PLANNING DEPARTMENT  
Staff Report & Recommendation

Design Review Board

SUBJECT: DRB20-0564  
**4354 Michigan Avenue**

An application has been filed requesting Design Review Approval for the construction of a new two-story residence including one or more waivers to replace an existing pre-1942 architecturally significant one-story residence.

North side interior courtyard, 2142 Michigan Avenue

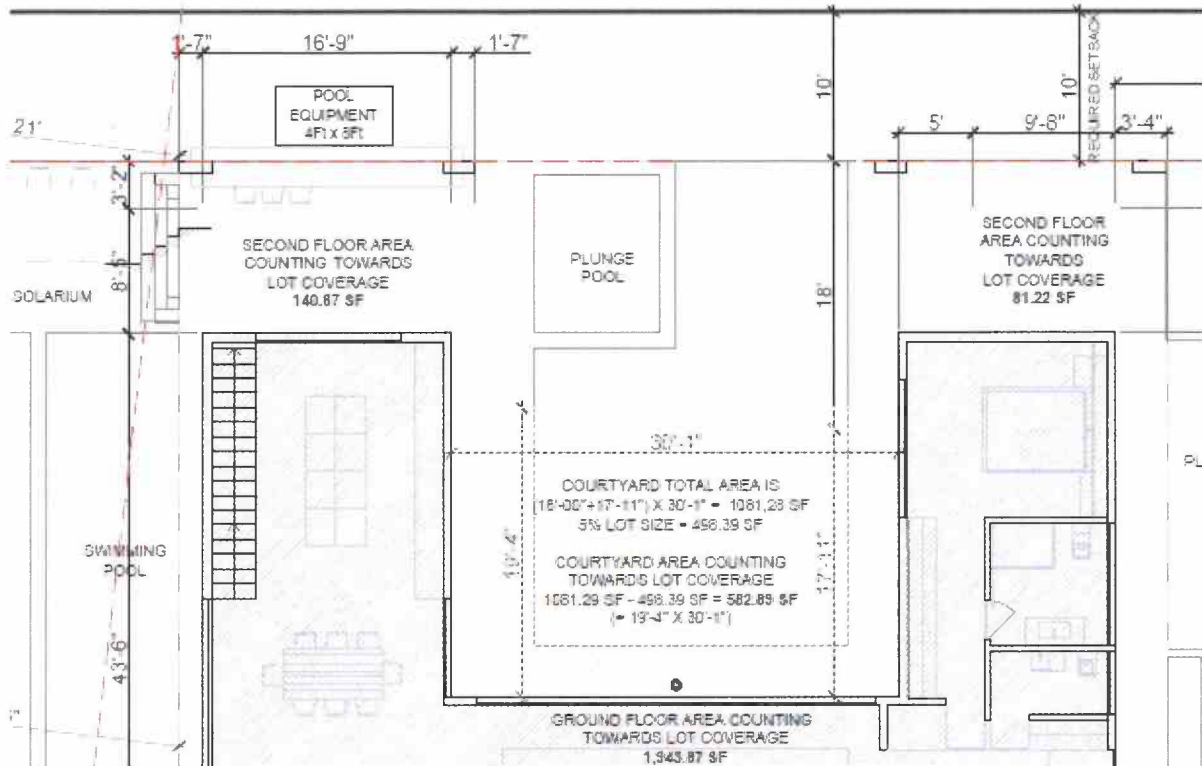
The applicant is requesting one design waiver that pertains to the open space requirements for two-story elevations that exceed 60'-0" in length. As previously mentioned, the proposed home features a large open space along the north interior side. The outdoor area measures 30'-1" wide by 35'-11' deep. This outdoor garden area is designed as a wide and deep recess that is set flush at the same elevation of the first finished floor of the residence with an elevation of 9' NGVD. Within the space, it has been designed and configured with landscaping, gravel and a plunge pool. It is the design intent of the team to integrate the architecture into the environment and maximize the sustainable nature of the architecture, reinforced through its compact footprint falling below the maximum unit size by 10%. The desire of the design is to maximize the natural environment through the centralization of the courtyard to emphasize natural passive cooling opportunities and in its orientation towards the north, move closer to achieving a zero-emission goal.

The open space provided along this side elevation is designed in the spirit of the regulations which is to break up the mass of side elevations in order to prevent uninterrupted sheer wall façades, but does not meet the restrictive code requirements of subsection 142-106(2)(d) as it pertains to elevation height, depth of the area and amount of landscaping. Critically, its size exceeds the courtyard size restriction and it has been designed at an elevation higher than adjusted grade and it is not 75% landscaped.

The provided open space is also configured with a depth that is 60% of the maximum developable building width of the property. Therefore, this excess area over 30%, or 18'-0', has been counted towards the lot coverage of the project. Additionally, the materiality of the space, as graveled area walkway and a garden with plunge pool, does not comply with the required 75% pervious landscape. The proposed open space addresses the intent of the ordinance by breaking up the two-story elevation and promoting light and circulation not only within the site but upon the abutting property as well. While the proposed elevation of the open space is elevated higher than adjusted grade, staff finds that the extent of open spaces provided mitigates any impact on neighbors, and as such is fully supportive of the design waiver.

- b. The proposed (north and south) side open space requirements **shall be** waived as proposed.
  - c. The required 70% limitation for the second floor volume **shall be** waived as proposed and shall not be increased at time of permitting, in a manner to be reviewed and approved by staff consistent with the Design Review Criteria and/or the directions from the Board.
